# Access Compliance Report

## Public Rights-of-Way

Intersection ID: 30152	Main Street: HARLAND_ST	Cross Street: KARNAK_CT	Location: W
ADA ID: 274CCD6E3838	Ramp Type: BlendTrans1	Initial Pass/Fail: Fail	Overall Compliance: No
		Severity Score: 12.5

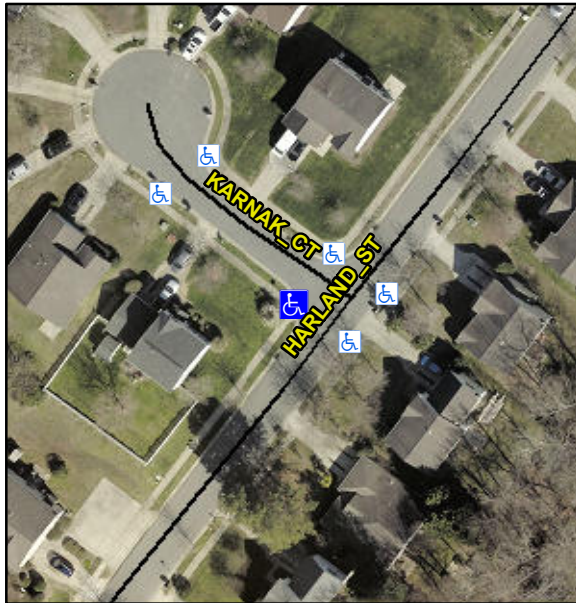
**Not Found, R304.5.3**

Compliance	Description	Data	Compliance	Description	Data
N/A	Ramp Length (in)	42.5	Yes	BlendTrans Slope (%)	4.1
Yes	Ramp Width (in)	48.0	No	BlendTrans XSlope (%)	5.1
N/A	Flare Type LT	N/A	N/A	Flare Type RT	N/A
N/A	Flare Slope LT (%)	N/A	N/A	Flare Slope RT (%)	N/A
N/A	Flare Traversable LT?	N/A	N/A	Flare Traversable RT?	N/A
N/A	Landing Length (in)	N/A	N/A	DWS Provided?	N/A
N/A	Landing Width (in)	N/A	N/A	DWS Contrast?	N/A
N/A	Landing Slope (%)	N/A	N/A	DWS Length (in)	N/A
N/A	Landing X Slope (%)	N/A	N/A	DWS Full Width?	N/A
N/A	Landing Curb? (Y/N)	N/A	N/A	DWS Offset (in)	N/A
N/A	Shared Landing?	N/A			
N/A	Gutter Ponding?	N/A	N/A	Gutter Slope (%)	N/A
N/A	Gutter Lip Ht (in)	N/A	N/A	Gutter X Slope (%)	N/A
N/A	Painted X Walk1?	No	N/A	Painted X Walk2?	No
	X Walk 1 Direction	To SE		X Walk 2 Direction	To NE
	X Walk 1 Width (in)	N/A		X Walk 2 Width (in)	N/A
	X Walk 1 Slope (%)	1.2		X Walk 2 Slope (%)	3.3
	X Walk 1 X Slope (%)	4.0		X Walk 2 X Slope (%)	1.1

N/A	Ramp inside XWalk1?	N/A	N/A	Ramp inside XWalk2?	N/A
	Road Slope (%)	1.9		Clear Space?	N/A
	Road X Slope (%)	2.8	N/A	Clear Space to XWalk (in)	N/A
N/A	Any Obstructions?	N/A	N/A	Storm Grate/Utility Hazard?	N/A
	Obstruction Type			Storm Grate/Utility Type	
		N/A			N/A
			Yes	Surface Condition? (G/P)	Good
			No	Curb Slope (%)	9.8

**Remove & Replace Curb Ramp With Two New Directional Ramps or Equivalent.**
